P.O.A.D.P. NO. 628-A

BRIDGEWOOD SUBDIVISION
SAN ANTONIO, BEXAR COUNTY
PRELIMINARY OVERALL AREA DEVELOPMENT PLAN

Re: Bridgewood (Amending)

POADP NAME: BRIDGEWOOD (AMENDING 628)

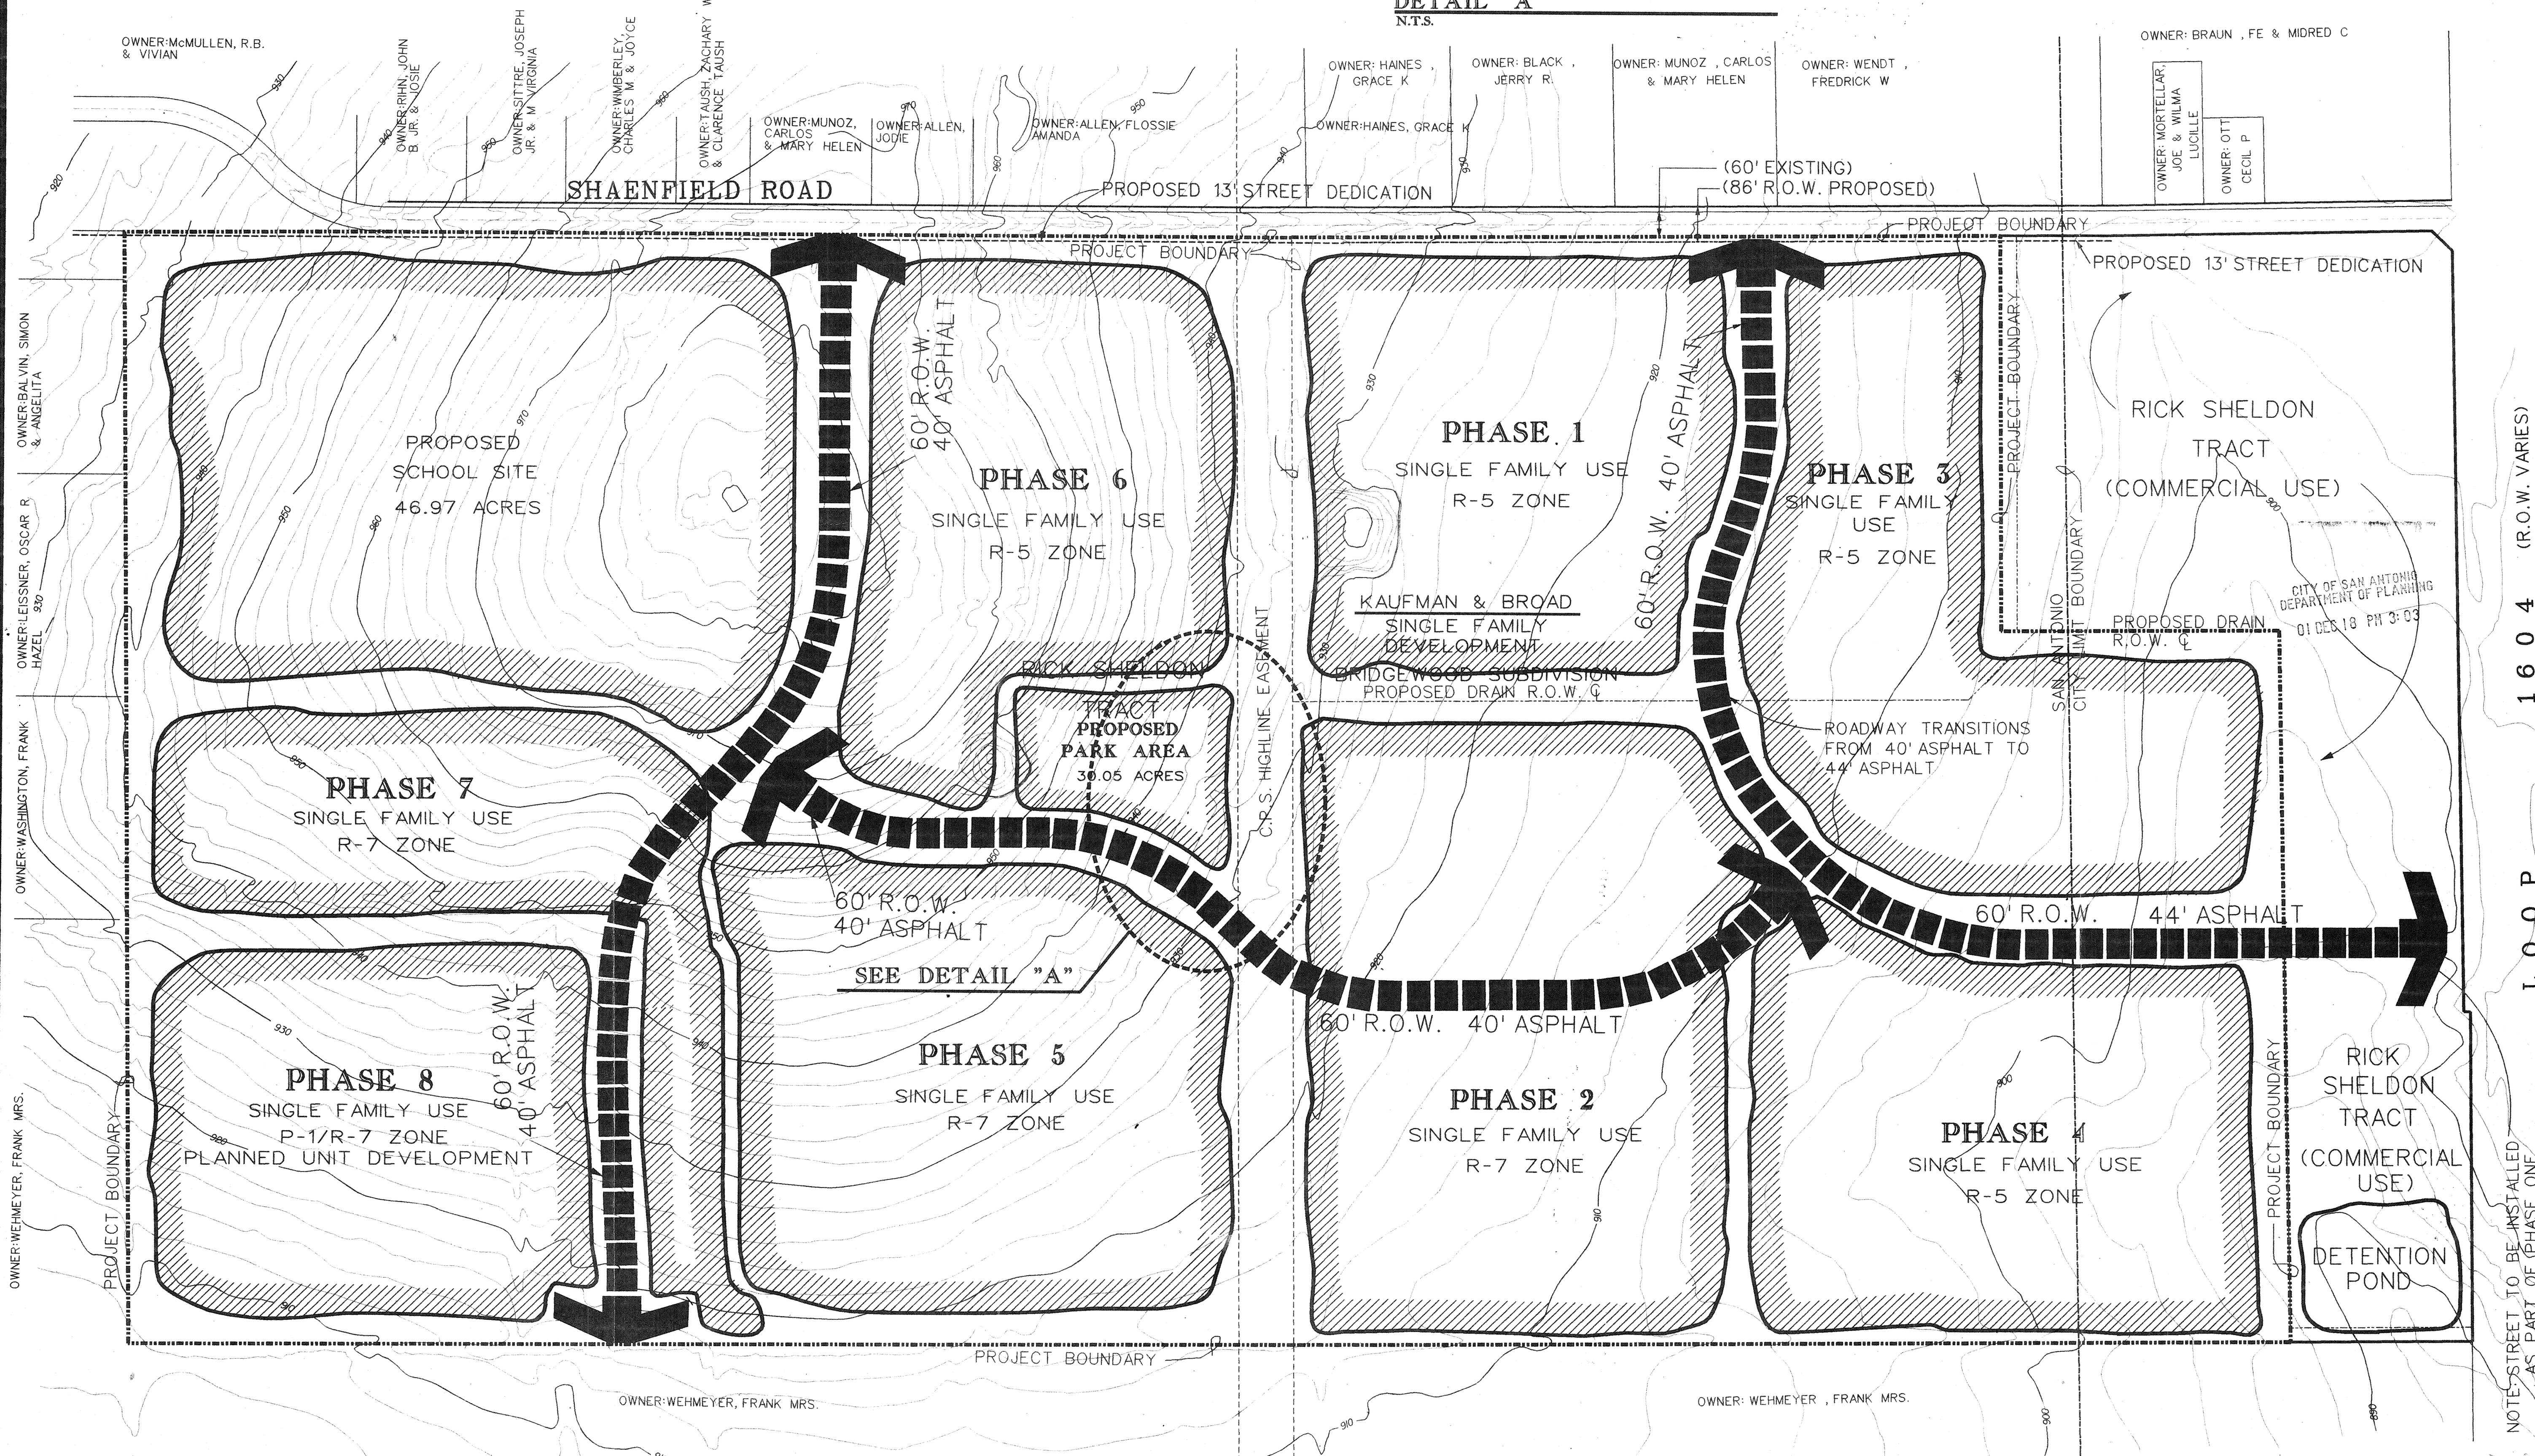
- In consideration of public safety and convenience, excessive grades by reason of topography should be avoided in street layouts and arrangements.
- Any access and R.O.W. issues along state facilities will need to be resolved with the Texas Department of Transportation (TXDOT). For information about these requirements you can contact TXDOT at 615-5814.
- This development will need to comply with tree preservation ordinance #85262. For information about these requirements you can contact Building Inspections at 207-7102.
- It will be expected that you will plat all of the property depicted in your Master Development Plan (M.D.P.) (formerly POADP), to include floodplains, drainage areas and open space.
- I would encourage you to work closely with the school district, so that they can plan accordingly.

Comments: LOOP 1604 IS ON THE MTP AND TXDOT SYSTEM REQUIRING
A MIN. OF 110' ROW AND TXDOT RELEASE. SHARNFIELD RD IS
ON THE MTP REQUIRING A MIN. OF 86' ROW.

Comments: ID#1998TIA1009
SHOW ACCESS INTO P.O.D.

Comments: I saw proposed private entrance
with the security gate. Cavern Hill must be
a collector. No houses fronting collector.

OCL
o indicate proposed uses as residential
only - not zoning districts.
